# SERVICE BULLETIN

SUBJECT: Norco, Inc. Strut Assembly A2711-3 rework to  
A2711-15 by installation of Sleeve AM2711-15-2.

**A2711-78-1**

**FIGURE 1 - STRUT ASSEMBLY A2711-15**

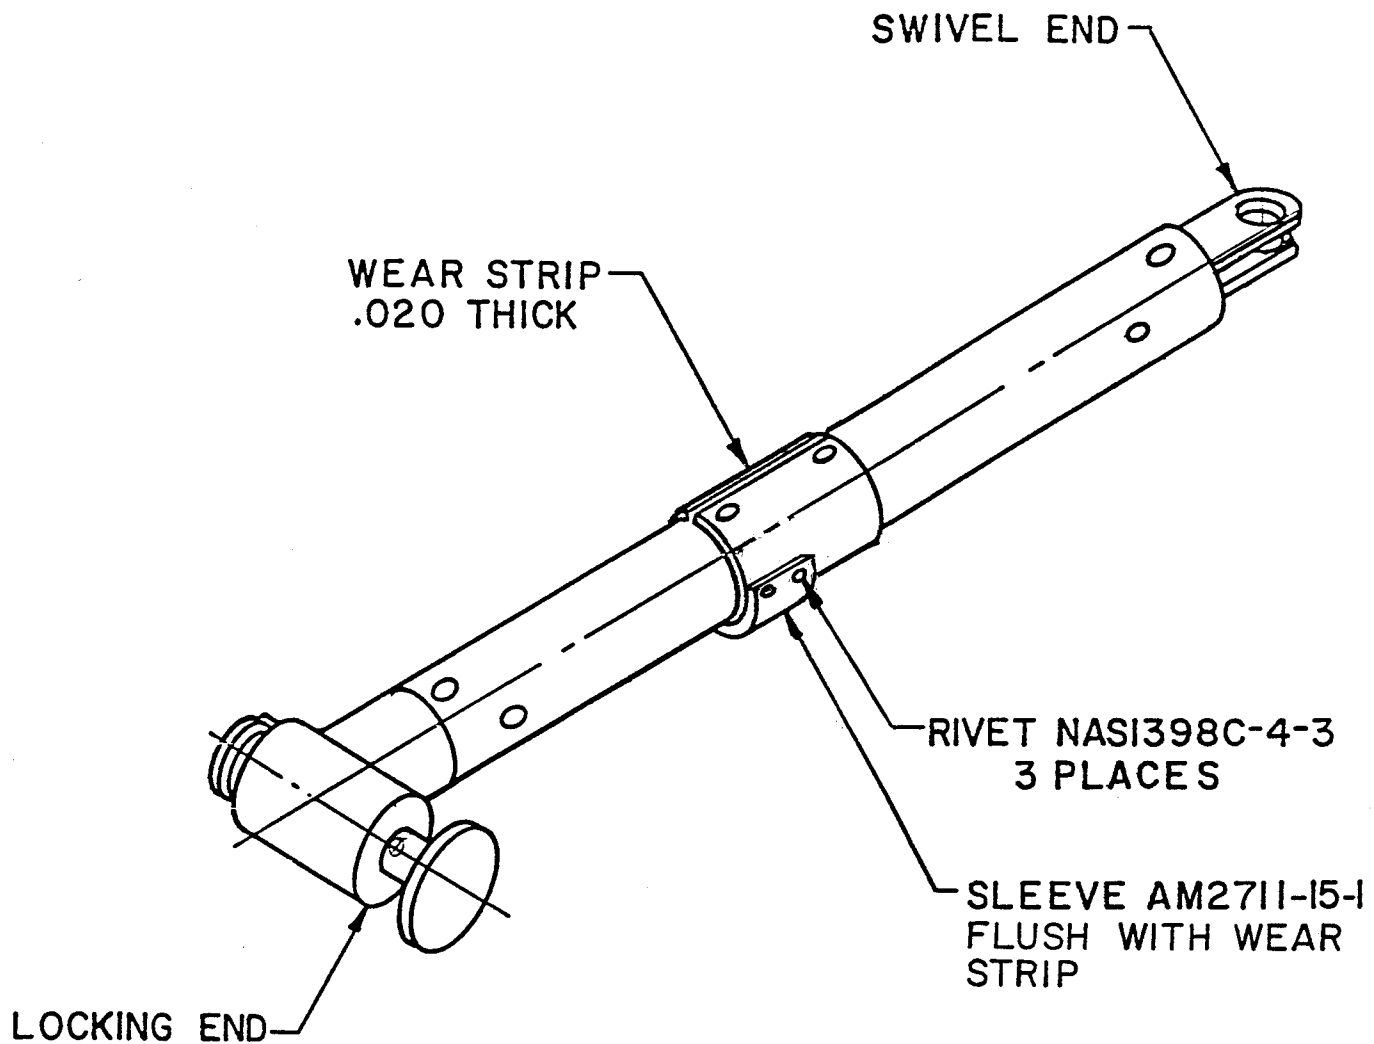
Prevent potential chafing of adjacent electrical harness.

1. Position sleeve (AM2711-15-2) as shown in Figure 1 and clamp in place.
2. Using sleeve (AM2711-15-2) as a drill template, drill through one wall with #29 drill (.136) in three places.
3. Remove sleeve (AM2711-15-2), deburr holes, and remove any loose metal chips.
4. Reposition sleeve (AM2711-15-2) and align with previously drilled holes.
5. Install one (1) NAS1398C-4-3 rivet and set rivet with installation tool.
6. Verify hole alignment on the remaining two (2) holes by inserting rivets and setting with installation tool.
7. Check that sleeve (AM2711-15-2) is tightly held at all three attachment points.

1. After incorporation of this service bulletin, the -3 part number should be removed by "X"ing it out with a vibroscribed tool.

2. Reidentify by vibroscribing -15.
